**AGENDA
PUBLIC WORKS
COMMITTEE**

**MONDAY, FEBRUARY 2, 2015
ROOM 202
5:30 P.M.**

5. Award of Contract for Project 14-1424 Southport Beach House Roof Replacement Rebid (7825 1st Avenue) to Carlson Racine Roofing & Sheet Metal, Inc. (Racine, Wisconsin) in the amount of \$316,000.00. (Park Funds Only) **(District 12)** *(Park Commission approved 5-0)*

ADDM 5-5

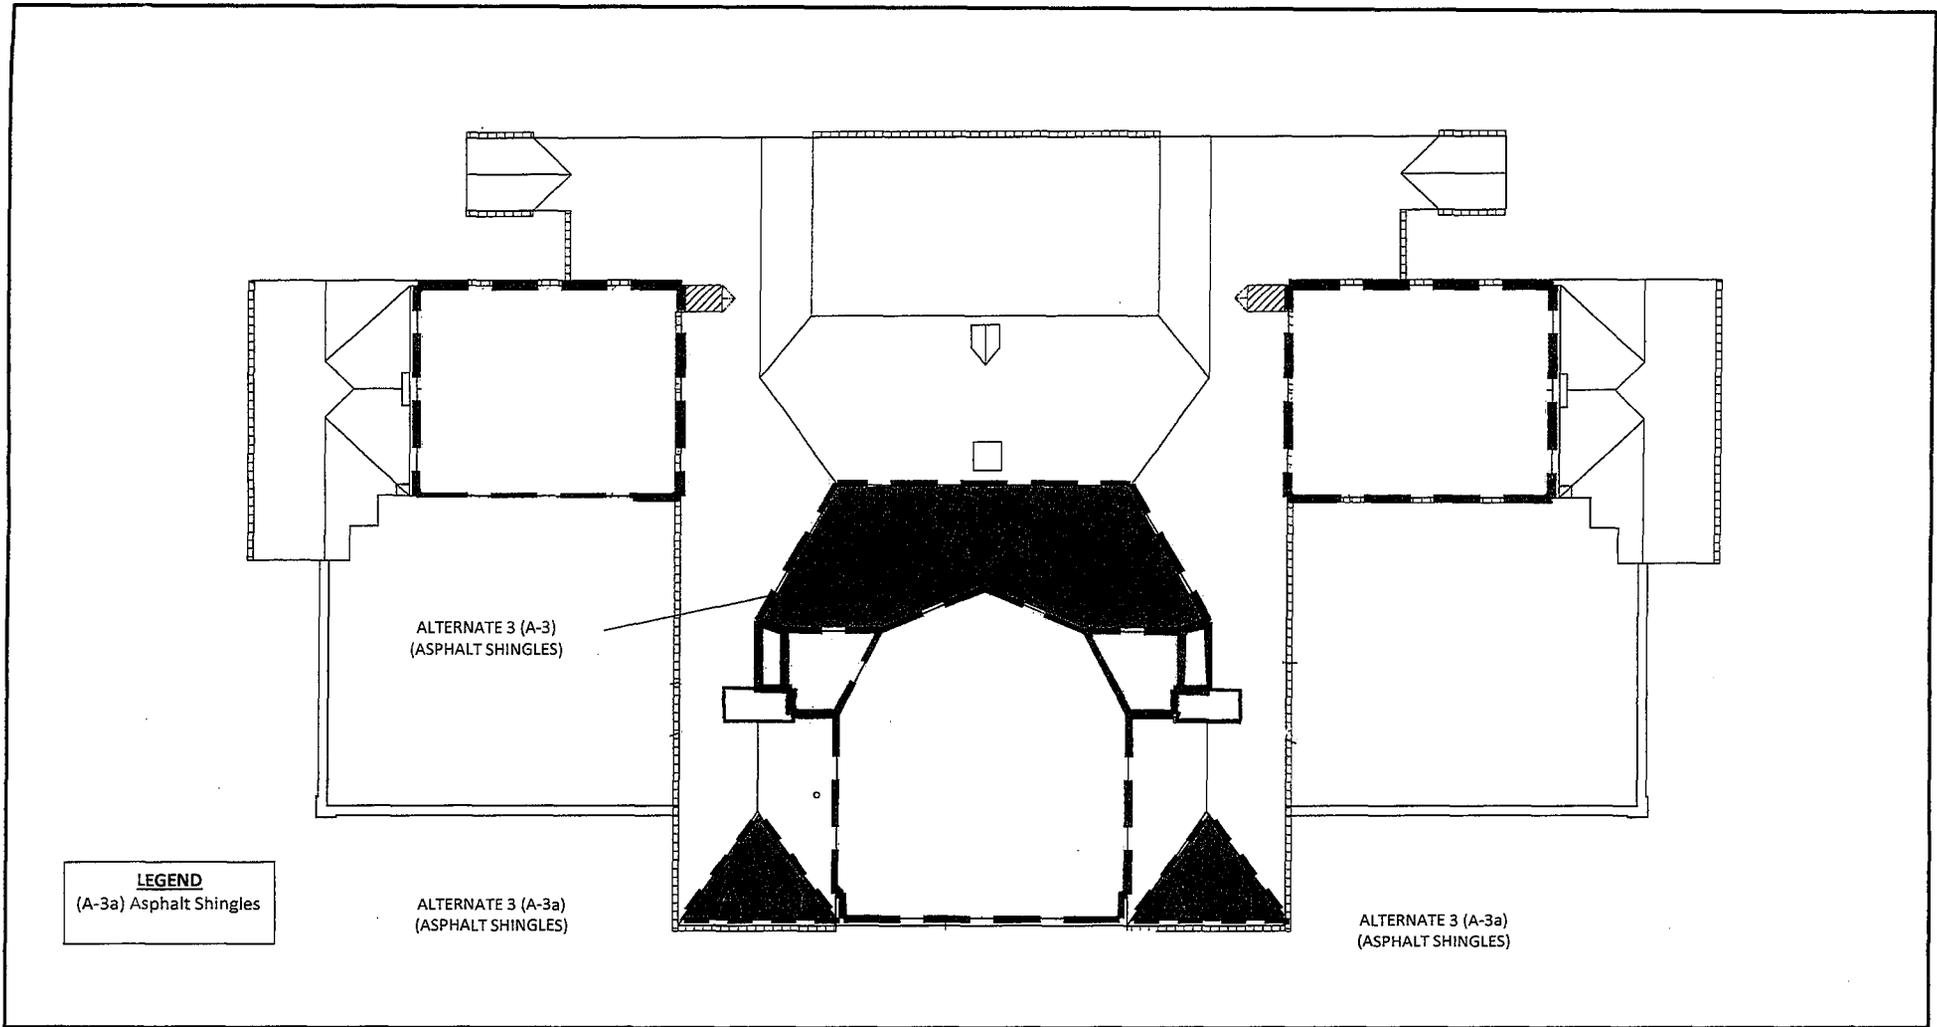
Replace drawings from Addendum 1 (ADDM1-A1.1, ADDM 1-A1.2, ADDM 1-A1.3) with the attached drawings ADDM 5-1, ADDM 5-2, ADDM 5-3, ADDM 5-4, ADDM 5-5, ADDM 5-6, ADDM 5-7 and ADDM 5-8. These drawings correspond directly to the revised Bid Form.
